CITY OF ALBUQUERQUE

RE: 4917 Tally Ho Ave. NW
Grading and Drainage Plan
Engineer's Stamp Date: 03/11/21
Hydrology File: A12D033

DRAINAGE AND TRANSPORTATION INFORMATION SHEET (REV 6/2018)

ENGINEER'S SEAL	LOT 53 BLK 18 PARADISE HTS UNIT 1 4917 TALLY HO AVE.		DRAWN BY DEM
	GRADING AND DRAINAGE PLAN		DATE 3-10-21
DAVID SOULE P.E. #14522	 RIO GRANDE Engineering P.O. BOX 53924 ALBUQUERQUE, NM 87199 (505) 321-8099		LOT 53 BLOCK 18 PARADISE HTS UNIT.DWG
			SHEET # C1
		JOB #

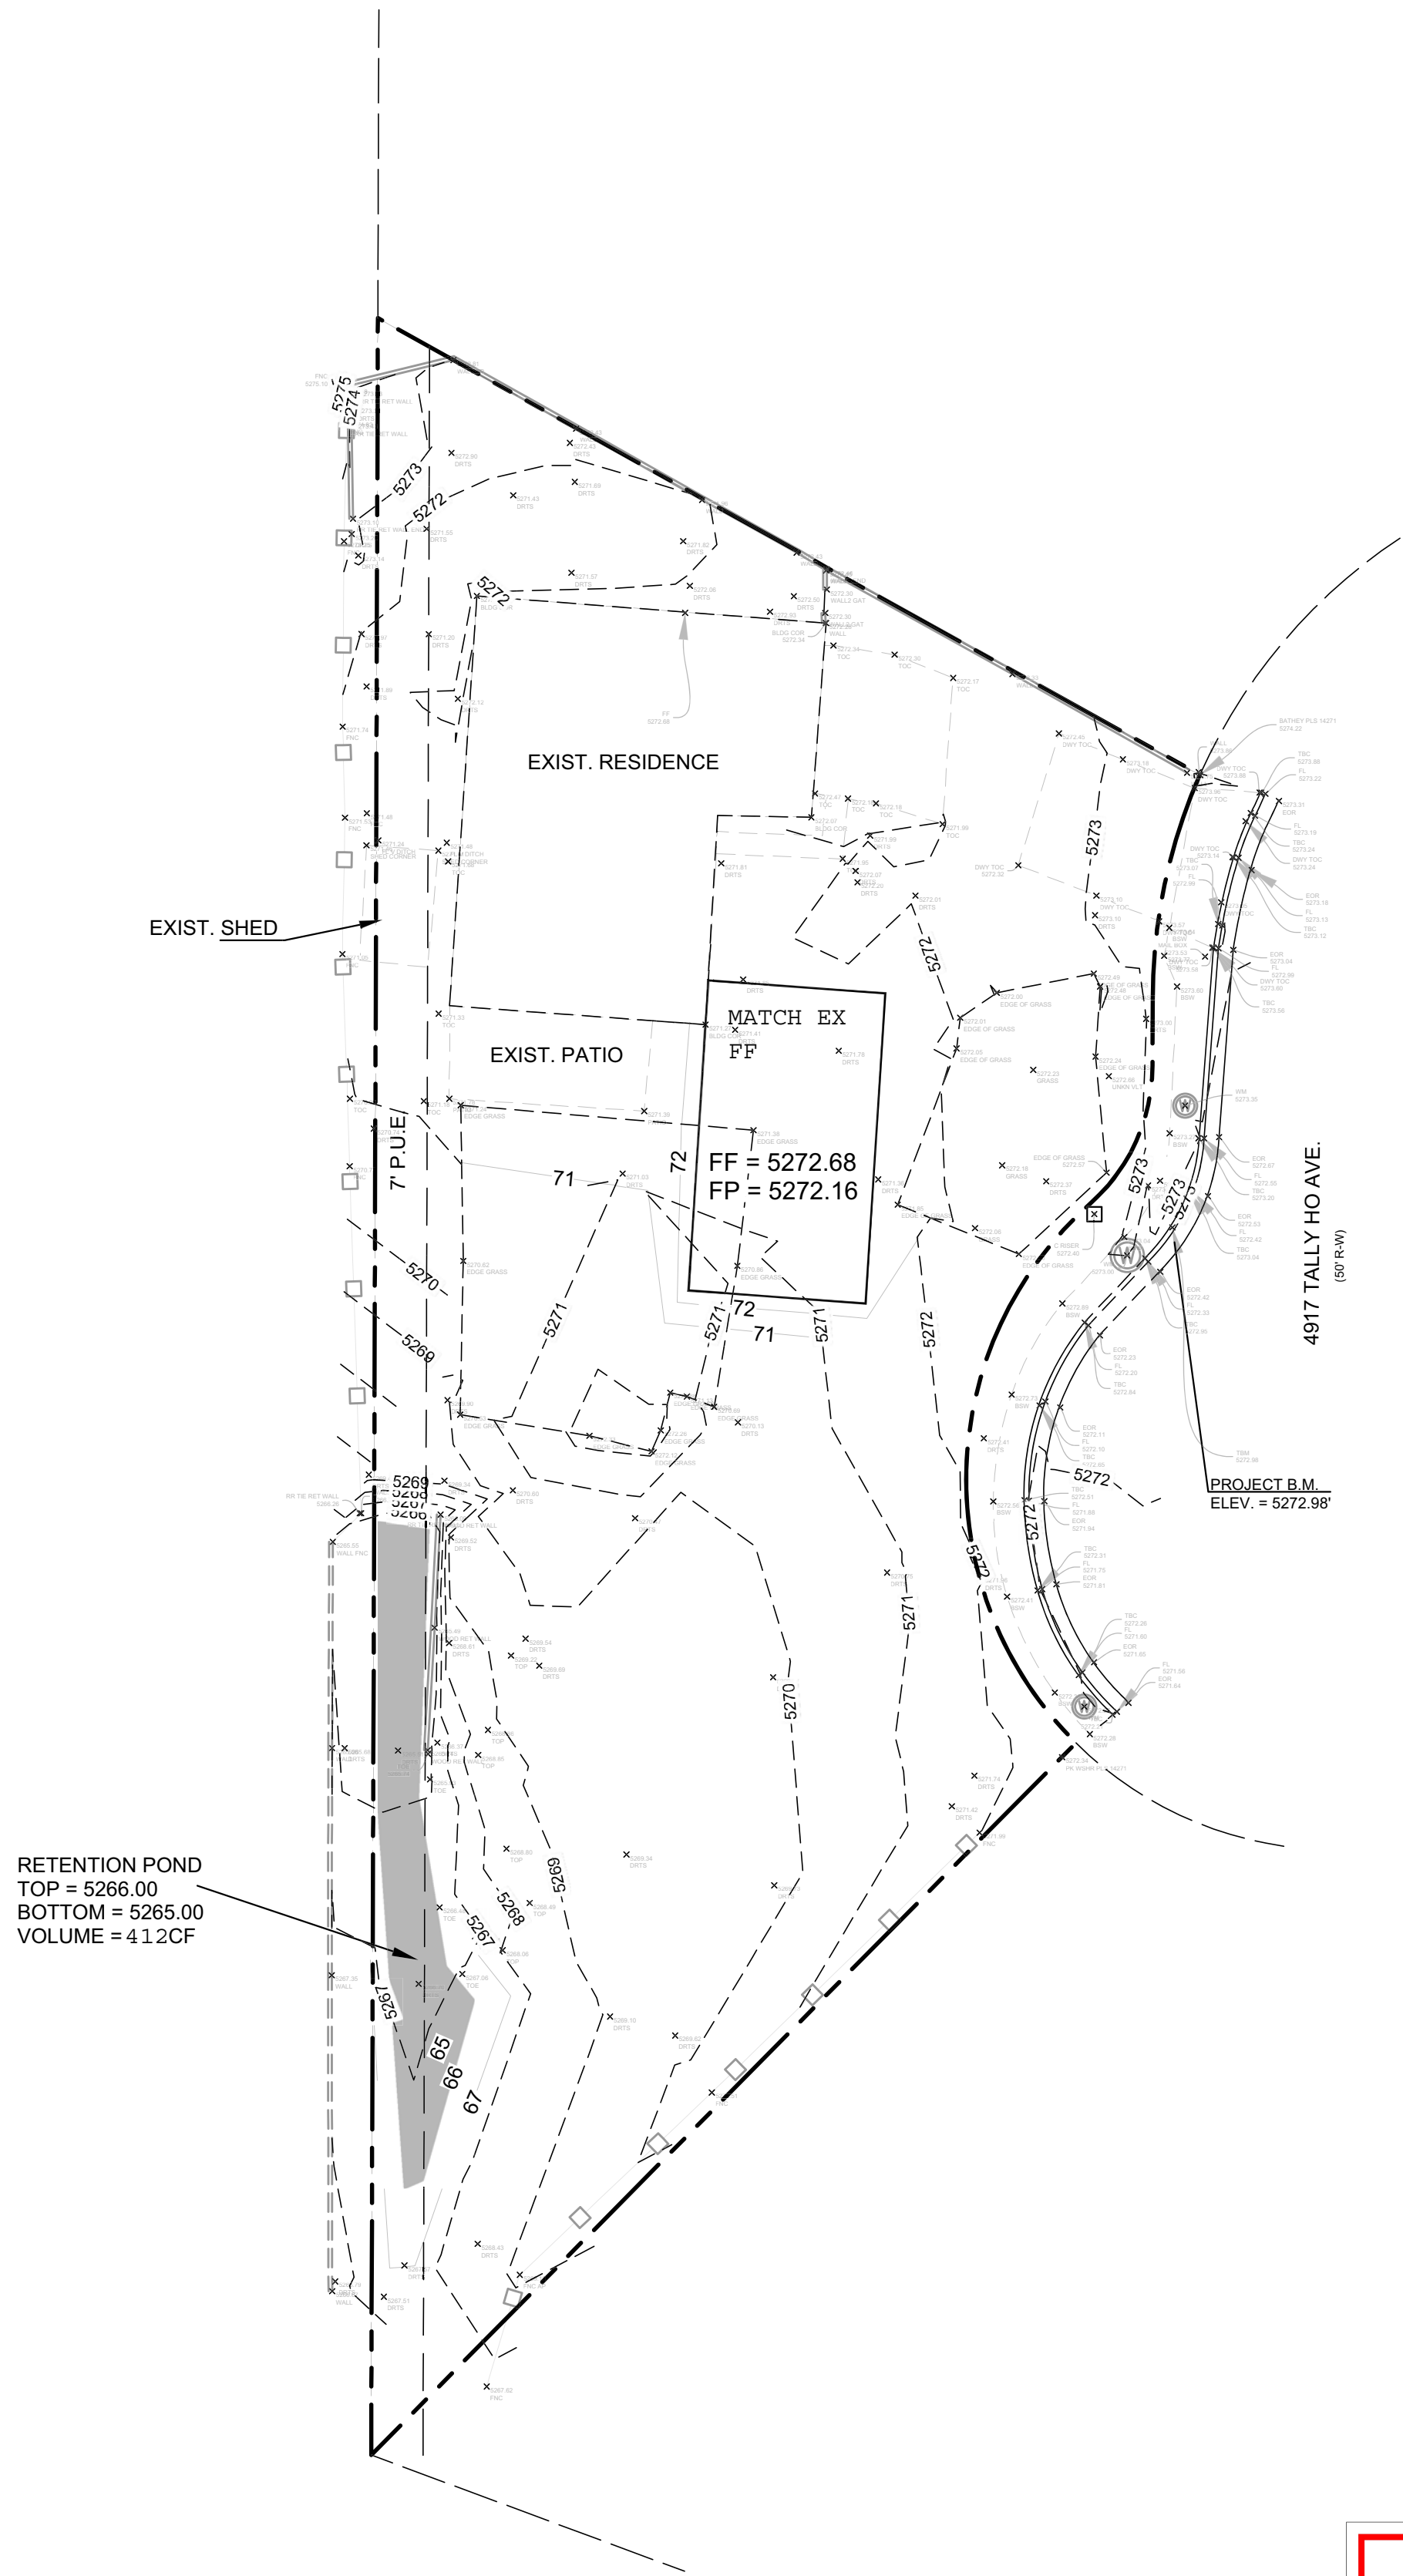
Based upon the information provided in your submittal received 03/11/2021, the Grading and Drainage Plan is approved for Building Permit and Grading Permit. Please attach a copy of this approved plan in the construction sets for Building Permit processing along with a copy of this letter. Since this site is currently has a house and where the addition is to be placed appears to have be relatively flat, pad certification will not be required.

Prior to approval in support of Permanent Release of Occupancy by Hydrology, Engineer Certification per the DPM checklist will be required.
